### **GFS Marketplace, JSP12-71**

Public hearing at the request of Sun Vally, Ltd. for a recommendation to City Council regarding the Preliminary Site Plan, Special Land Use and Stormwater Management Plan. The subject property is located in Section 15 south of Twelve Mile Road and west of Donelson Drive in the RC, Regional Center District. The subject property is 2.15 acres and the applicant is proposing an approximately 16,000 sq. ft. GFS Marketplace retail store.

# PLAN REVIEW CENTER REPORT

**SUBJECT: GFS Marketplace, JSP12-0071,  
Traffic Review of Preliminary Site Plan (PSP12-0059)**

Typical details for alternative treatment of barrier-free parking ramps

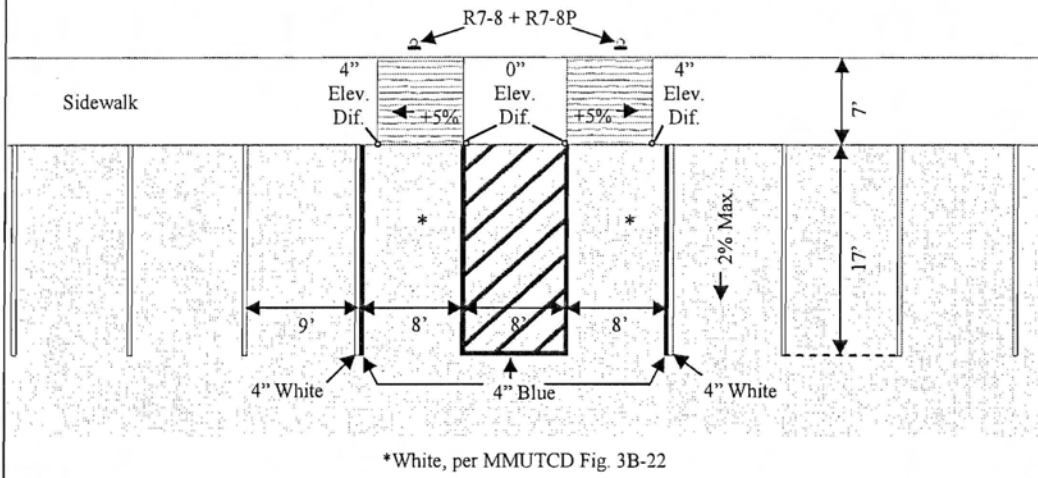
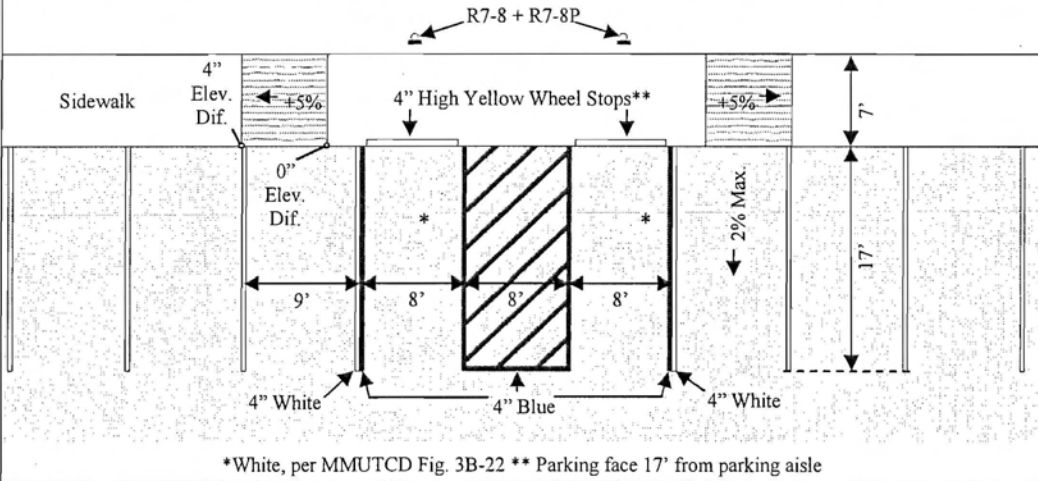
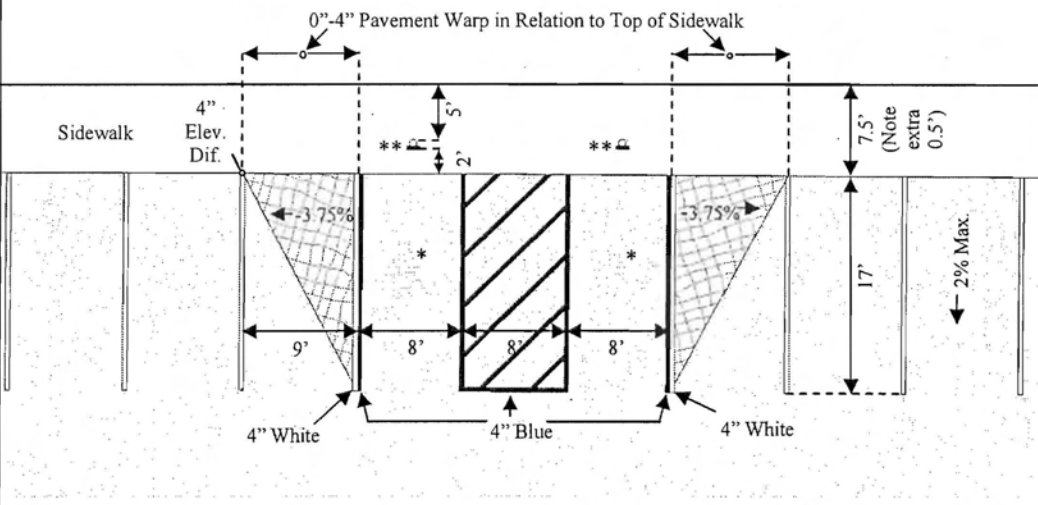
- b. **Striping color of blue (not yellow per the current plan note), with adjacent barrier-free and non-barrier-free spaces separated by abutting blue and white stripes.**

11. **The plan note specifying various barrier-free parking features also needs to be revised to remove an obsolete reference to a "precast bumper block" (which will not be used) as well as inaccurate references to "a sign" (rather than two for each space) and the "Manual of Uniform Traffic Controls" (an incorrect title).**

- 10.) Barrier free parking spaces will be further revised in accordance with both ADA and City requirements, as noted in comments a – d.
- 11.) Any reference to precast concrete bumper blocks will be eliminated (they are no longer proposed as part of this project).

**SITE PLAN**

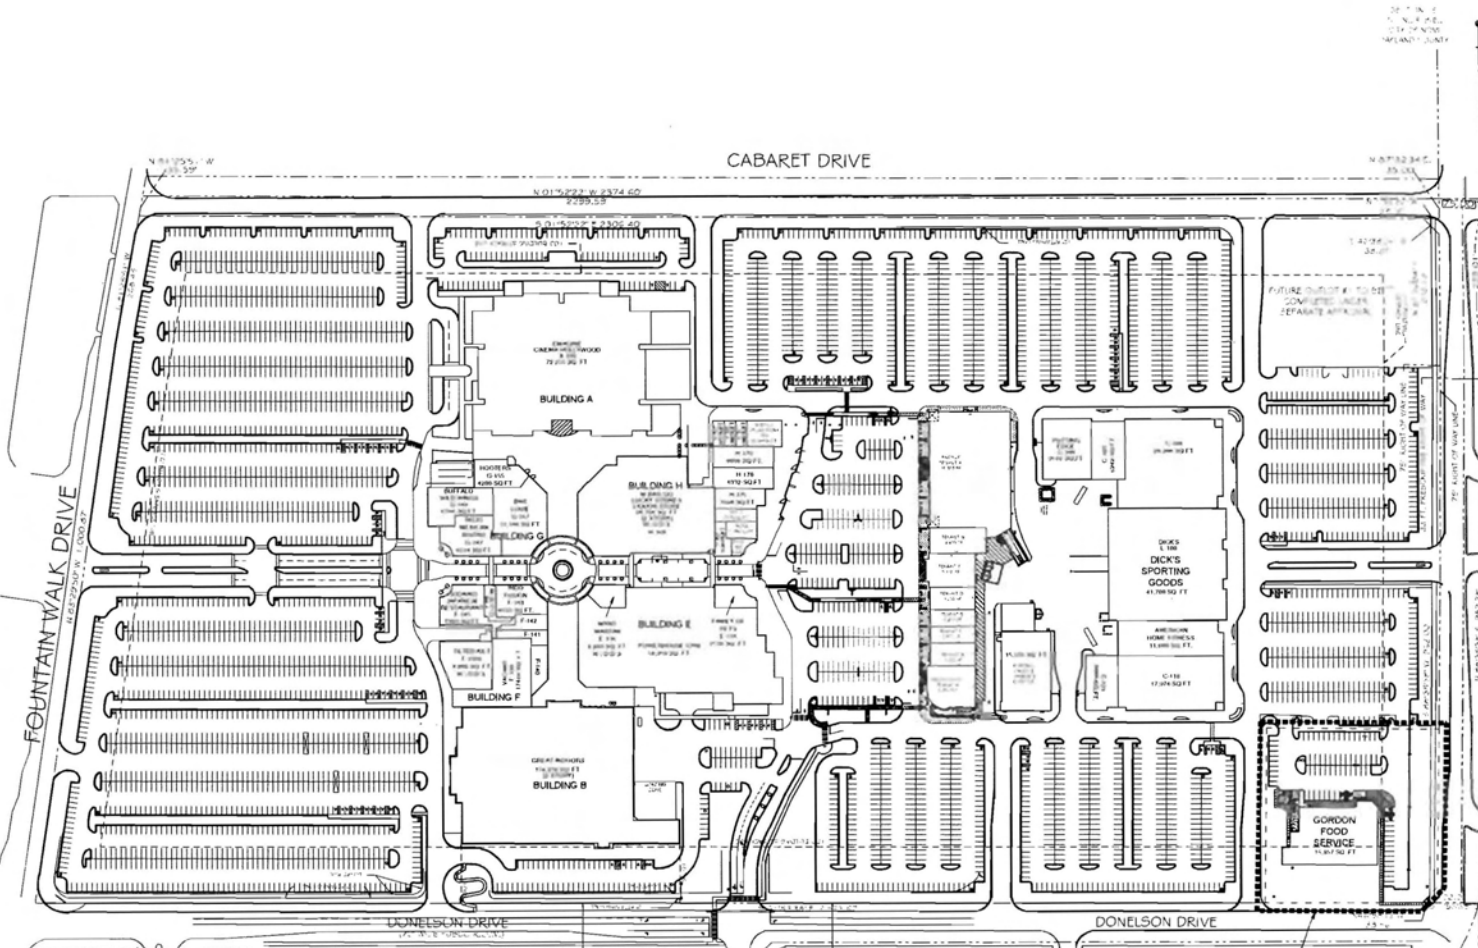
1. Building Setbacks: Buildings must be setback 100 feet from all property lines. The proposed building is setback 65 feet along the east property line and 28 feet along the south property line. The applicant has elected to seek variances from the Zoning Board of Appeals for these deficiencies. **If the variances are not granted, plans will need to be modified to meet the ordinance standards.**
2. Parking Setback: Parking areas must be setback 10 feet along side and rear property lines. The proposed parking setback in the western side yard is 4 feet and the proposed setback in the southern rear yard is 3 feet. The applicant has elected to seek variances from the Zoning Board of

7. A note on sheet C-102 states that "all dimensions shown to concrete curb and gutter are to back of curb unless otherwise noted." **This note should be expanded, or supplemented by another note, to indicate that "all parking space dimensions (width as well as length) are referenced to face of curb or walk."**

9. As requested, the sidewalk around the building has been widened to 7 ft; however, the adjacent parking spaces have been shortened only to 18 ft rather than the 17 ft requested; **the applicant should explain the need for the 1 ft of extra pavement** (rather than landscaping behind the sidewalk). Also, any space length less than 19 ft requires the sidewalk height to be limited to 4 inches (per Sec 2509.3.c(2)(c) of the Zoning Ordinance). Although we are unable to find any relevant elevation data in the plans, **it appears from a note on sheet C-103 ("Slope sidewalk down 6" so flush with bituminous pavement at striped aisle") that the sidewalk height is now proposed to be an unacceptable 6 inches.**

12. **The proposed no parking zone immediately south of the main building entrance lacks a striping specification as well as any signage. A NO PARKING ANY TIME sign (R7-1 but with no arrow below) should be mounted on the building façade to the right of the window (see west elevation on sheet A-201). The crosshatching specification for this zone should match the one used at the northwest corner of the building pad (4-inch yellow, 4 ft on-center). With the installation of the requested sign, the words "NO PARKING" apparently intended as a pavement marking are optional.**

- We have submitted for the various variance requests noted in the staff report, and expect to receive these approvals at the March ZBA meeting.
- Parking spaces located adjacent to the building will be revised to provide a 4" tall curb, and these spaces will also be shortened to 17' long (currently shown as 18' long).
- Dumpster screening will be provided on three sides (north, east and south) with a 6' tall masonry wall matching the building materials. A wood gate on the west side will complete the dumpster enclosure.
- Subsequent site lighting plans will include the average to minimum ration to demonstrate compliance with 4:1 maximum per zoning ordinance

- 9.) Parking spaces adjacent to the building were reduced to 18' (from 20' on Concept Plan), and will be further reduced to 17' at the time of final site plan submittal. At that time, the sidewalk height will be clarified as 4" tall (not 6" as noted).

- 12.) A "No Parking Any Time" sign will be added to the north side of the west elevation of the building as noted.
